WARRANTY BULLETIN

WB13-56

DATE :	SEPTEMBER 2013	SECTION :	12 - Brakes
EXPIRATION:	SEPTEMBER 2015		
SUBJECT :	AIR LEAK ON AIR DRYER PROBE

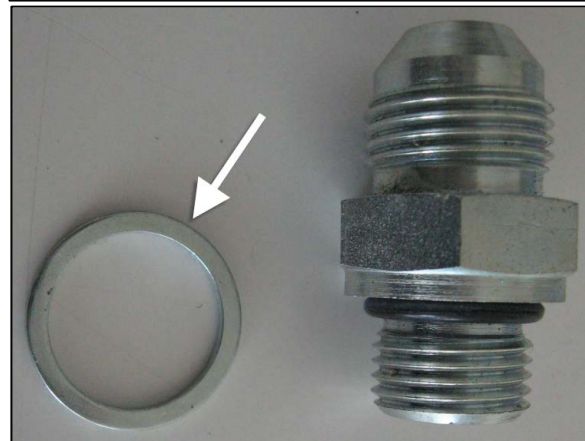
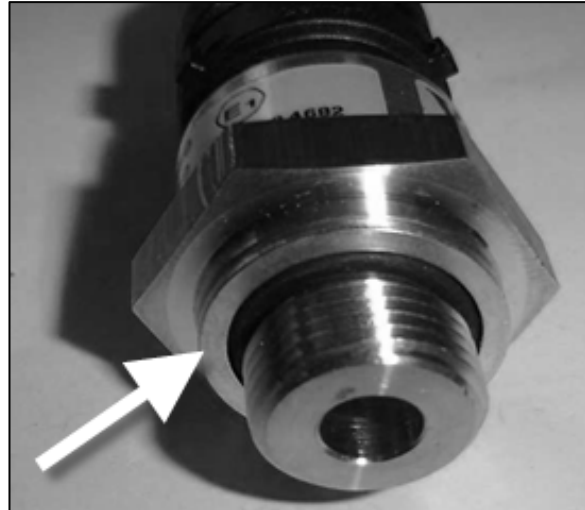
On the vehicles affected by this bulletin, the air dryer assembly may present a leak at the pressure probe connection. The O-ring in this location may be deformed due to the fitting arrangement. Adding a metal ring will prevent this issue.

5. If you have fitting 641294, take this ring to install on the probe.

6. Add ring 504789 at arrow location and re-install probe on air dryer assembly.

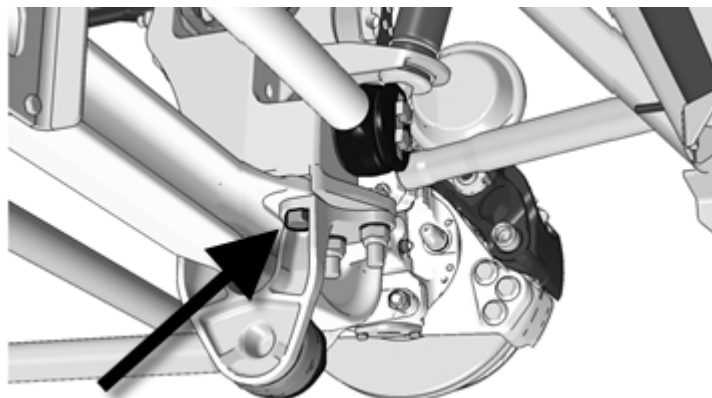
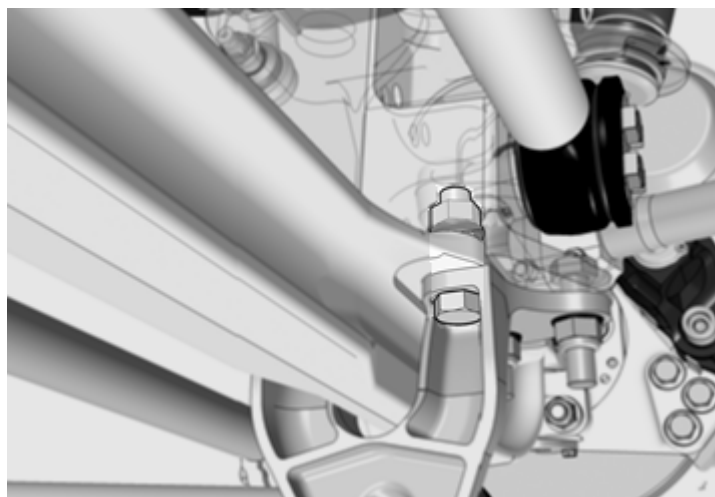
On the vehicles affected by this bulletin, torque must be verified on one of the axle support mounting bolts.

1. On the front axle, left side (driver's side). Locate this bolt (arrow).

2. Verify the torque on this bolt.

255 +/- 25 lbf-ft. (**230 - 280** lbf-ft).

3. If torque is outside the required range, unscrew half a turn and tighten to 255 lbf-ft.
